United Nations ECE/TRANS/WP.29/GRRF/2014/22

Seventy-eighth session
Geneva, 16-19 September 2014
Item 5(b) of the provisional agenda
Motorcycle braking – Global Technical Regulation No. 3

Proposal for amendments to Global Technical Regulation No. 3 (Motorcycle brake systems)

Submitted by the representative from Italy*

Conventional Brake System	*Combined Brake System (CBS)*	
Architecture A	***Architecture B***	***Architecture C***

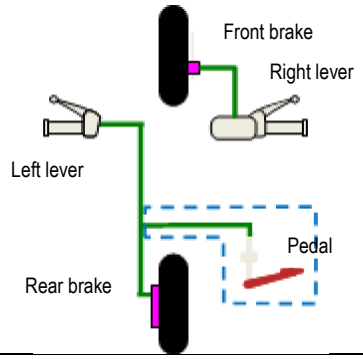
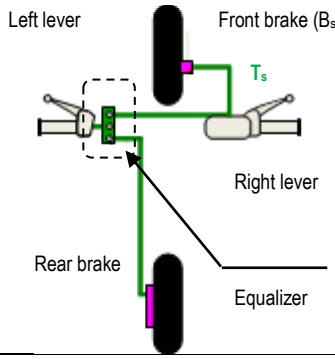
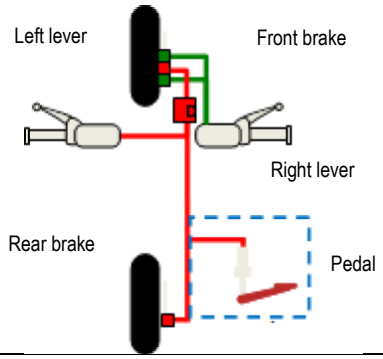
21. Architecture B is an example of a CBS that shares a transmission (T_s) and a brake (B_s).

Other CBS architectures such as Architecture C

24. A failure test is not necessary for this type of CBS architecture because there are no shared components with the exception of a brake cylinder, which is one of the components that are regarded to not be liable to breakage.

"3.1.9. In cases where two separate service brake systems are installed, the systems may share a common brake~~, if a failure in one system does not affect the performance of the other~~ **a common transmission, or both** if **the requirements of paragraph 4.12. are met.**"

CBS Architecture B

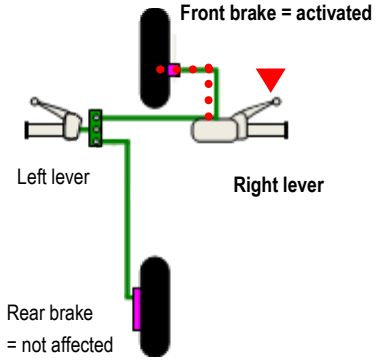
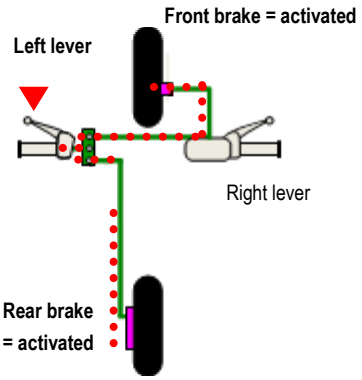
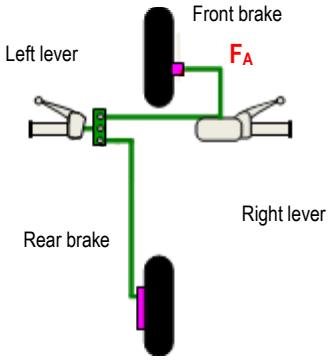
22. While a failure in e.g. the "front system" (F_A) may affect the performance of the CBS, the rear system (operated by the left lever) will continue to be operational.

Front brake	Defect
Rear brake	Operational by left lever

23. In order to ensure that, in case of a failure in one system, the performance of the other system still equals that of a conventional system, it is proposed to allow that two separate brake systems share a brake and/or a transmission, provided that the other system meets the single brake system performance requirements in case of a failure of such shared components(s). To that end, a failure test is proposed for CBS brake systems of Architecture B. Italy is of the opinion that such a failure test requirement should ensure the acceptance of such a CBS in terms of demonstrated robustness and guaranteed minimum braking performance.

"**4.12. CBS failure test**

(a) Alter the brake system to produce a failure causing a complete loss of braking in the portion of the system which is shared.

(b) Perform the dry stop test specified in section 4.3. in the laden condition. Other conditions to be observed are 4.3.1. (c) and 4.3.2. (a), (b), (d), (e) and (f). Instead of the provisions in section 4.3.2. (c), only apply the control for the brake not affected by the failure."

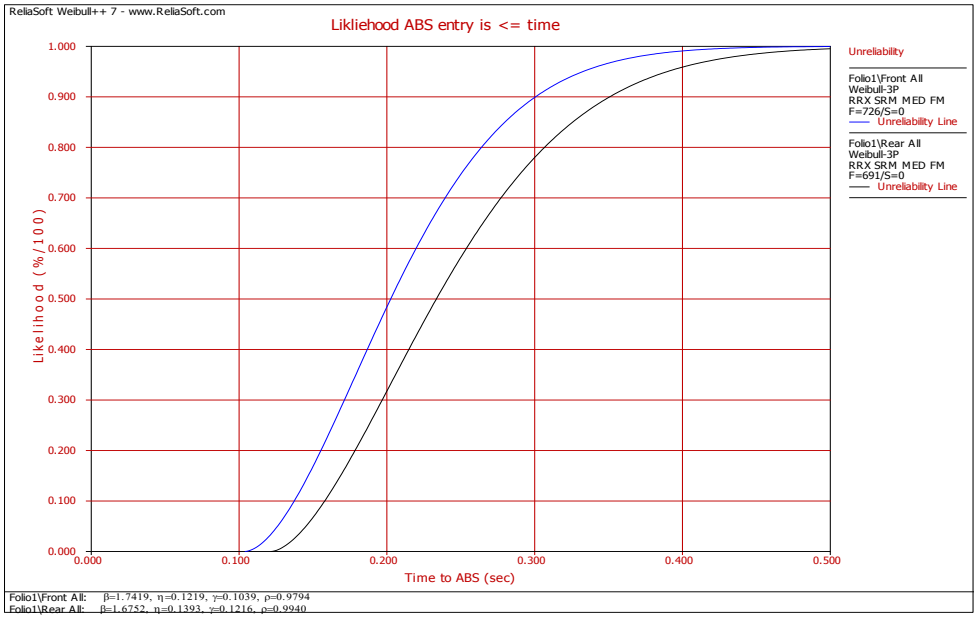
33. It has been noticed in testing that the brake application rate specified in paragraph 4.9.5.1. can result in a large number of test failures. If can be seen in the chart below that the 0.2 second lower limit shows a failure rate is between 30 per cent and 50 per cent of the time.

34. By reducing the lower limit to 0.1 seconds the test failure rate reduces to practically zero. Allowing the reduction tends to make the regulation more stringent by including a greater number of brake force application rates and eliminates restrictive test requirements.

The brake control actuation force is applied in ~~0.2~~ **0.1** – 0.5 seconds."
